### MERCED: WRITTEN COMMENTS FOR MARCH 20, 2019 PLANNING COMMISSION MEETING (BRIGHT DEVELOPMENT VTSM # 1291)

# ATTACHMENT 16 - Page 1

ATTACHMENT C - Page 5

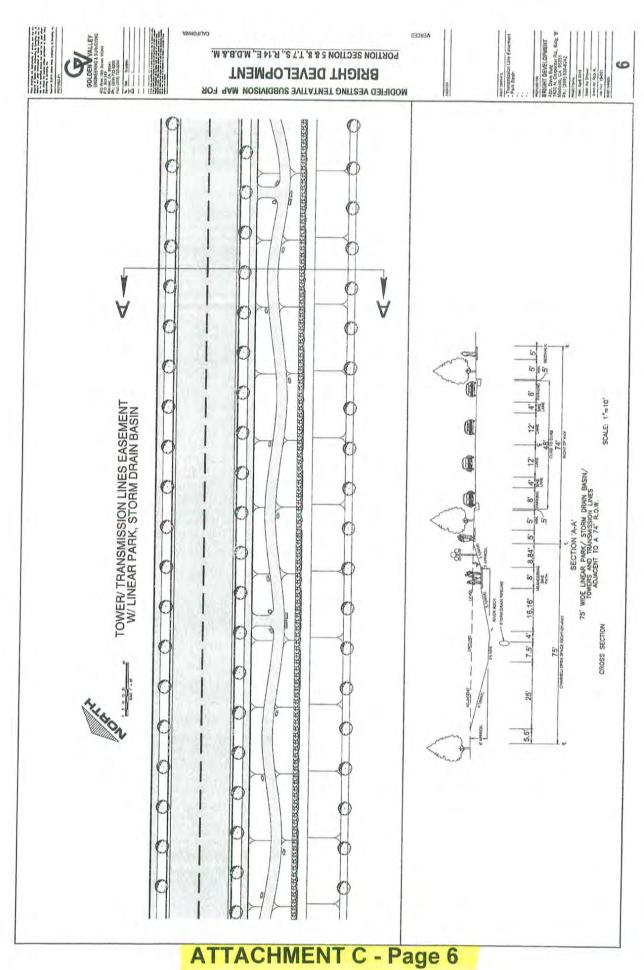
- \* On "Attachment C--page 5" (attached), "EASEMENT WIDTH SCHEDULE" included in your staff report, identifies the PG & E easement as eighty (80) feet in width, ½ (or 40 feet), on Bright's property and the other ½ (40 feet) on ours (BP Investors, LLC). Yet, "Attachment C--page 6" (attached) it shows the subdivision planned with a street and autos on one (1) portion of "Section A-A" (74 feet), and the remaining portion of "Section A-A" (75 feet), as a planned storm-drain basin/swale (8 to 12.5 feet deep). That storm-drain basin/swale appears to be depicted ½ on our property (within the 75 feet). Consequently, approximately 35 feet would extent into our Village Residential development where we intend to locate some of our required parking and a drive-aisle.

Because the applicant's plan offers only one (1) cross-section of the power-line easement proposed for a storm-drain basin/swale with an adjacent roadway (and autos), as shown on "Attachment C, page 6", the only reasonable conclusion one could make is that it represents a large majority of the length of that PG & E easement area, including that portion along our City approved student-housing project (CUP # 1200), which the City will likely want to review.
